Project	IEEE 802.16 Broadband Wireless Access Working Group < http://ieee802.org/16 >	
Title	Corrections for the Protocol Stack of Security Layer	
Data Submitted	2005-05-04	
Source(s)	Seokheon Cho Taeyong Lee Jaesun Cha Chulsik Yoon ETRI Yong Chang SAMSUNG Yongjoo Tcha KT Li Rui, Tian Feng ZTE corporation	Voice: +82-42-860-5524 Fax: +82-42-861-1966 chosh@etri.re.kr 161, Gajeong-dong, Yuseong-Gu, Daejeon, 305-350, Korea
Re:	IEEE P802.16e/D7	
Abstract	The document contains suggestions on the changes into IEEE 802.16e/D7 that would correct the protocol stack of security layer.	
Purpose	Adoption of proposed changes into P802.16e/D7	
Notice	This document has been prepared to assist IEEE 802.16. It is offered as a basis for discussion and is not binding on the contributing individual(s) or organization(s). The material in this document is subject to change in form and content after further study. The contributor(s) reserve(s) the right to add, amend or withdraw material contained herein.

Corrections for the Protocol Stack of Security Layer

Proposed changes to IEEE 802.16e/D7

Figure 130j- Security sublayer

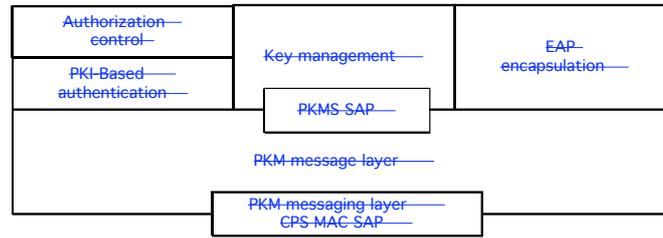
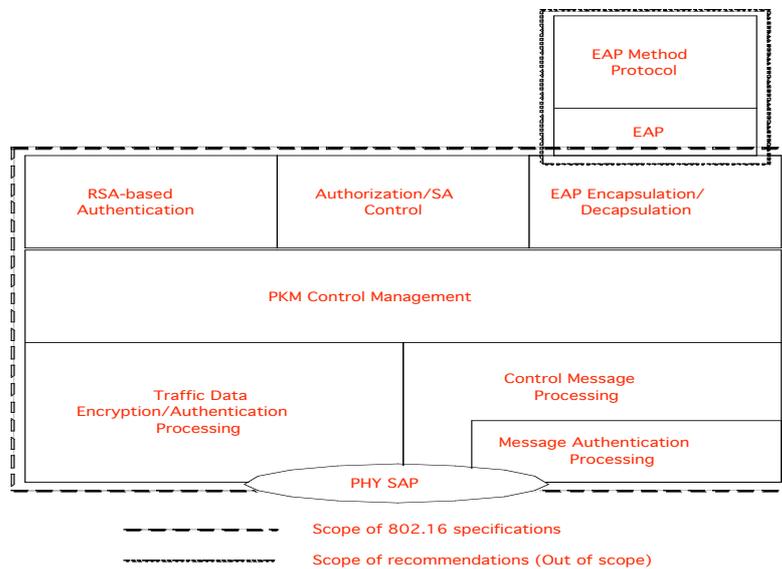
However, the protocol stack doesn't fully support all security sub-functions; it skips some important security components and is wrong-arranged.

The new following security components need to be considered, compared to the existing security protocol stack (Figure 130j and Figure 130k).

[Exchange Figure 130j for the following new Figure and Add contents below Figure 130j as follows:]

- PKM Control Management: This stack controls all security components. Various keys are derived and generated in this stack.
- Traffic Data Encryption/Authentication Processing: This stack encrypts or decrypts the traffic data and executes the authentication function for them.

- Control Message Processing: This stack processes the various PKM-related MAC messages.
- Message Authentication Processing: This stack executes message authentication function. The HMAC, OMAC, or several short-HMACs can be supported.

- RSA-based Authentication: This stack performs the RSA-based authentication function using the SS's X.509 certificate, when the RSA-based authorization policy is negotiated between an SS and a BS.

- EAP Encapsulation/Decapsulation: This stack provides the interface to the EAP-related authentication protocols, when the EAP-based authentication or the authenticated EAP-based authorization policy is negotiated between an SS and a BS.

- Authorization/SA Control: This stack controls the authorization key state machine and the traffic encryption key state machine.
- EAP and EAP Method Protocol: These stacks are out of scope.

Figure 130k-Comparison of the Basic and Extended Privacy Layers (Control plane)

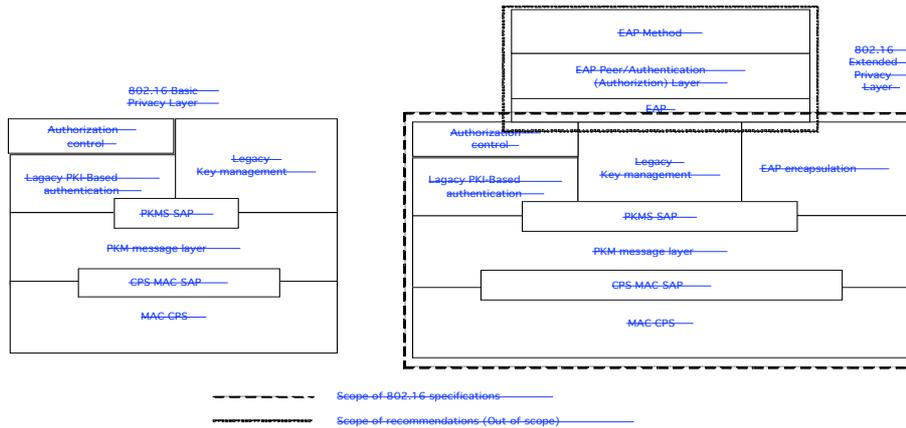
[Modify the sub-clause 7.1.3.2 as follows:] and [Delete Figure 130k]
